**Title:** Answer to the LS on Antenna Interface Standards Group (AISG)  
**Response to:** RP-030122  
**Release:**  
**Work Item:**

**Source:** RAN  
**To:** AISG

**Figure 6.1: Transmitter test ports**

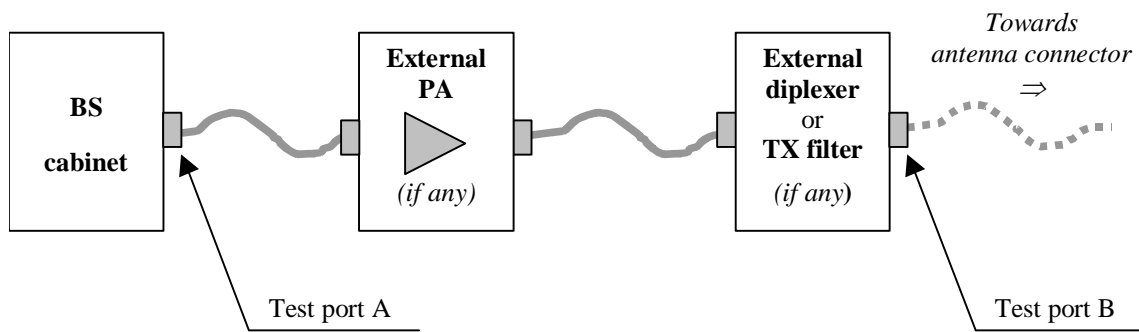
2. The reference point used for performance requirements of the base station is the antenna port. In the current European R&TTE directive requirements all tests are performed at this reference point, it is unclear how these tests would be performed when a base station supporting the in-band signalling is tested (for example the in-band signal spectrum mask would fail the spurious requirements). RAN 4 is also aware of similar requirement in other regions of the world.

According to the current specification TS 25.104 the reference point in case of using auxiliary equipment like TMA etc. is Test port B. The so-called L1 Converter as considered in AISG Specification may belong also to such kind of auxiliary equipment.

**Question:** AISG is kindly asked whether this is in line with the AISG Specification?
